Project Title: American Toyota Building Permit #: _____ City Drainage #: C18d012
DRB#: _____ EPC#: _____ Work Order#: _____
Legal Description: Tracts A1 and B-1, American Toyota and lots 15-18 tract a unit b NAA
City Address: 5995 Alameda NE

**RE: Revised Grading Plan (C18-D012)
HLP Endodontics
Albuquerque, New Mexico**

RE: American Toyota (File: C18D012)
Drainage Report, Engineer's Stamp Date 3-16-15
Grading and Drainage Plan, Engineer's Stamp Date 3-17-15

ENGINEER'S SEAL  3/27/15 DAVID SOULE P.E. #14522	AMERICAN TOYOTA GRADING AND DRAINAGE PLAN  1806 CENTRAL AVENUE SE SUITE 201 ALBUQUERQUE, NM 87106 (505) 872-0999	DRAWN BY WCWJ
		DATE 3-27-15
		21403-LAYOUT-1-25-14
		SHEET #
		JOB # 21403

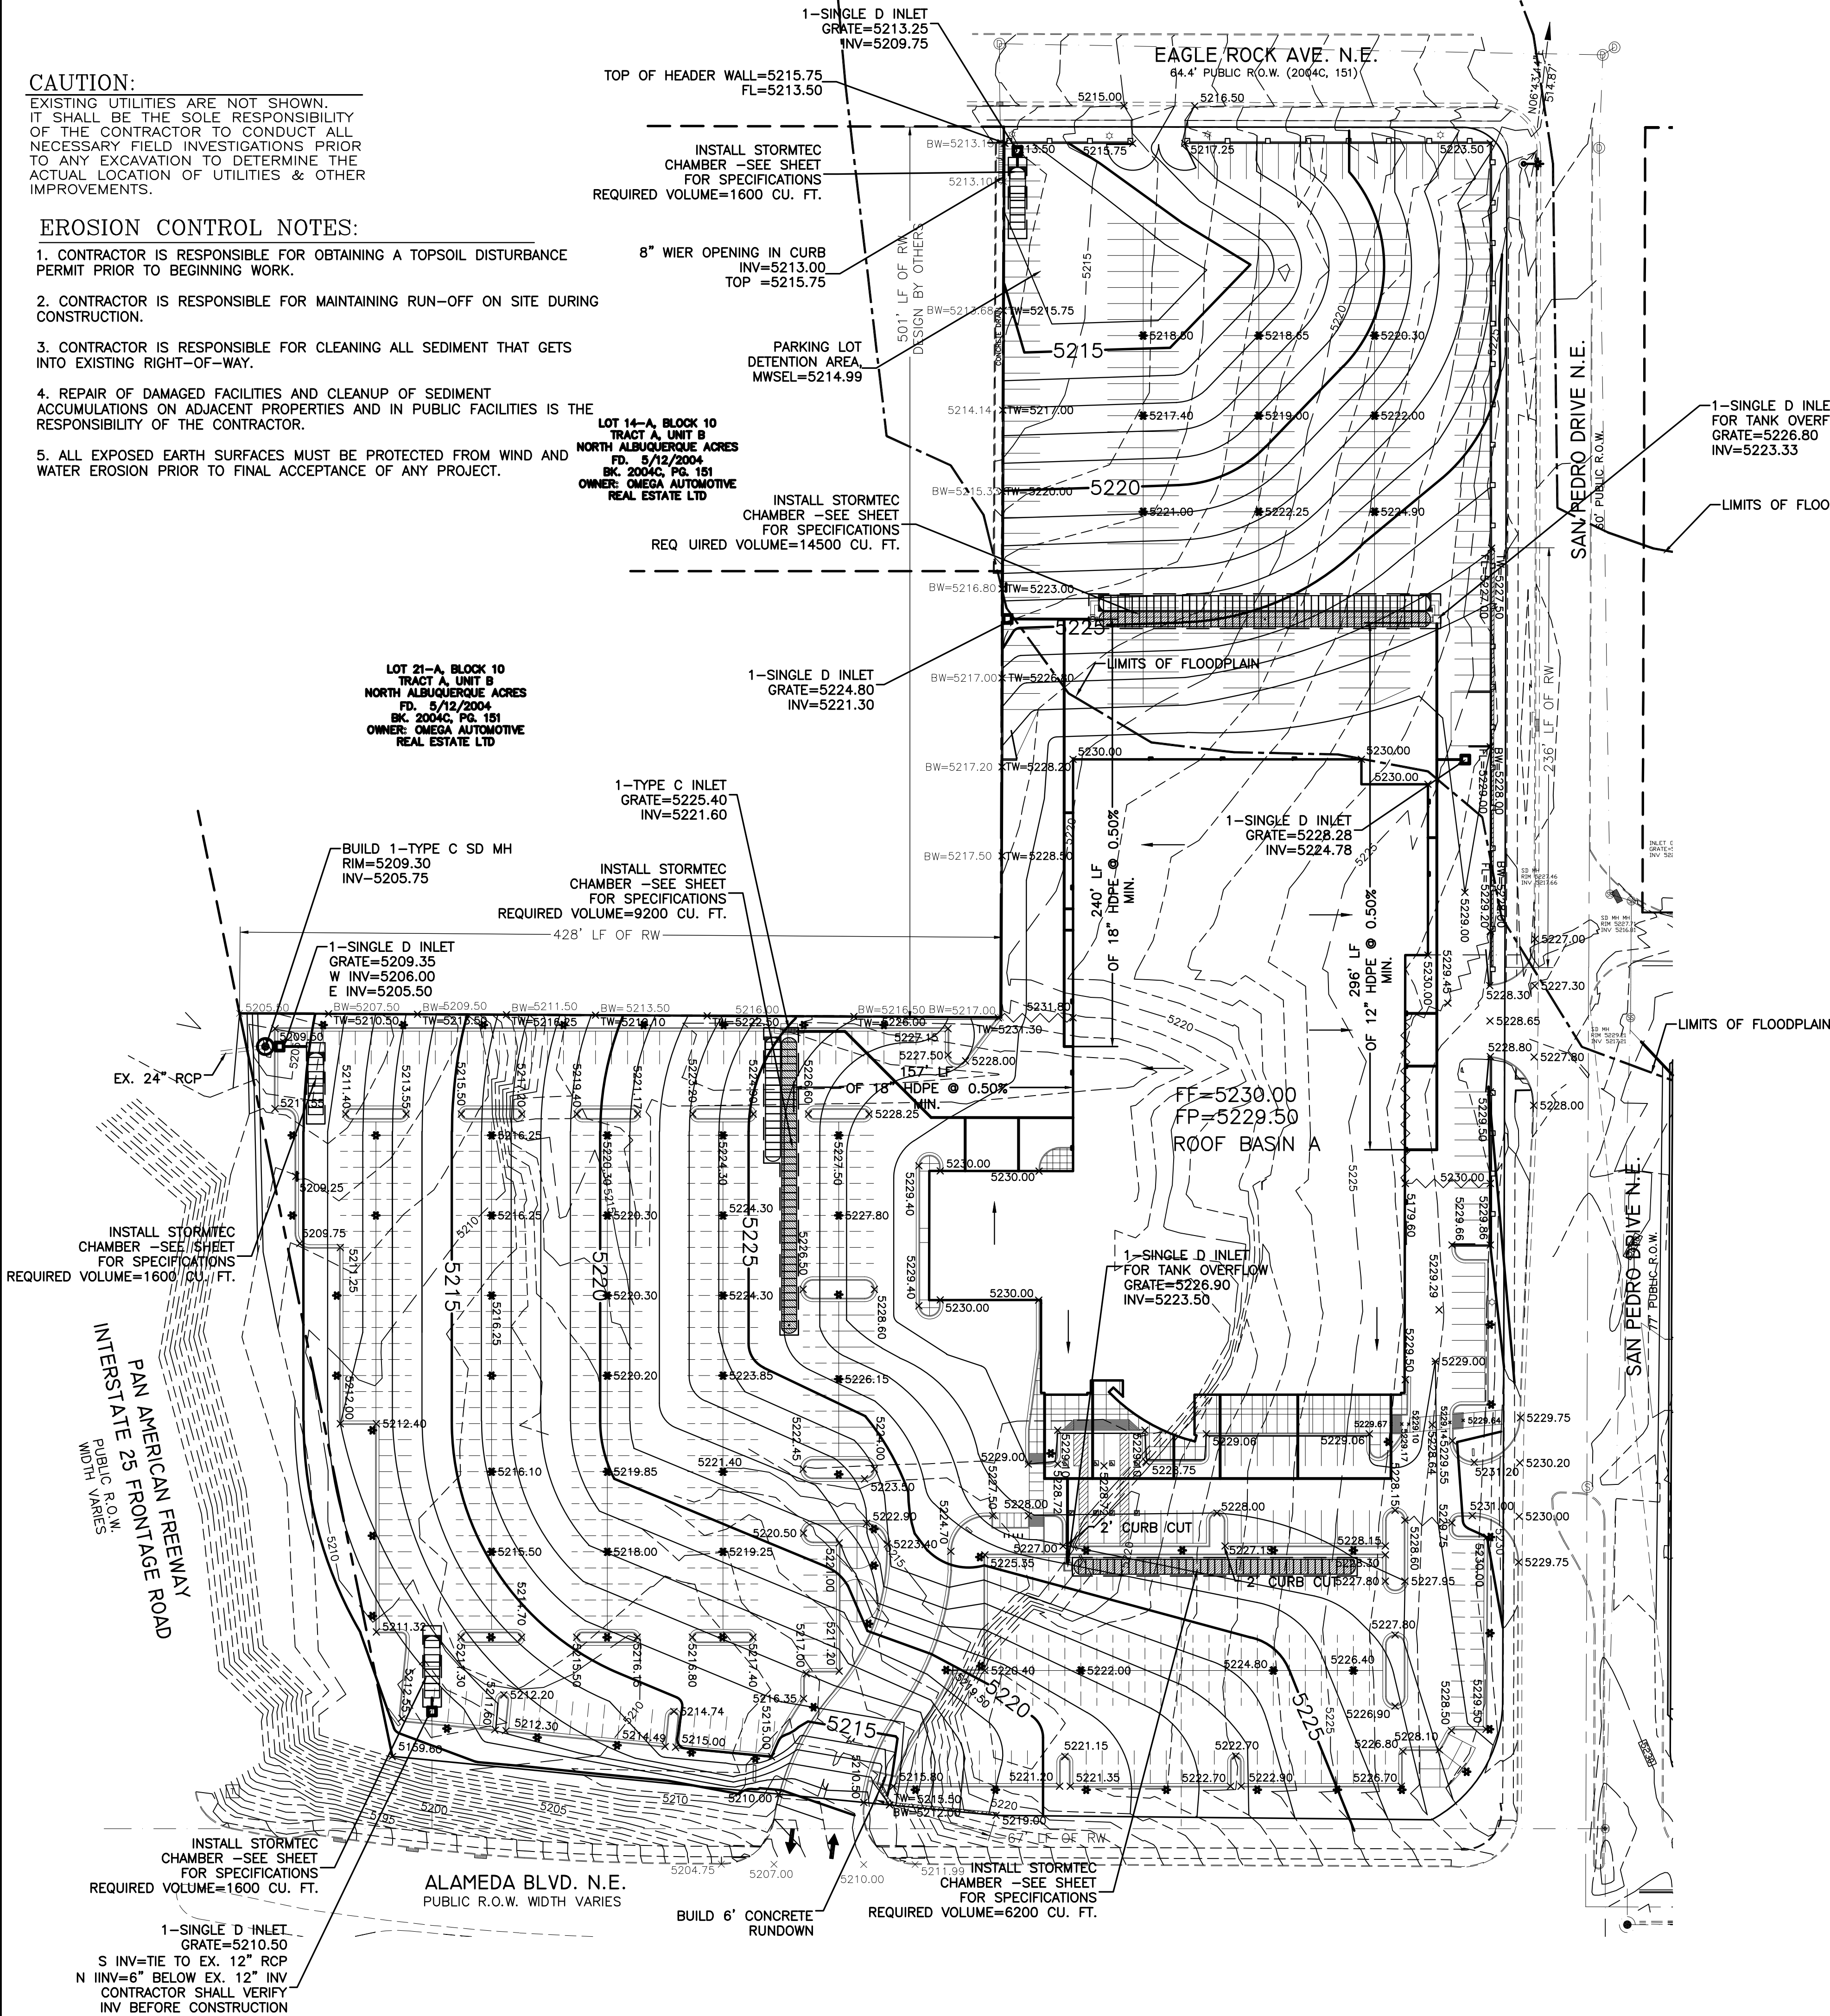
1. Proposed runoff limited to 25 cfs

2. Add first flush capture at outfalls 2,3,4

3. Detail how first flush mechanism works

The grading plan as approved for site plan approval shows 25.5 cfs. The addition of the 3200 cubic feet of additional water quality tanks at the out falls will reduce the flow to below 25 cfs

We have added 1600 cubic feet harvest chambers at each outfall. The water harvest from this site contains all the work area and exceeds the required volume.

We have an inlet and holding tank just before the outfall. The inlet captures all the flow until the tanks are filled then the water passes over inlet to outfall
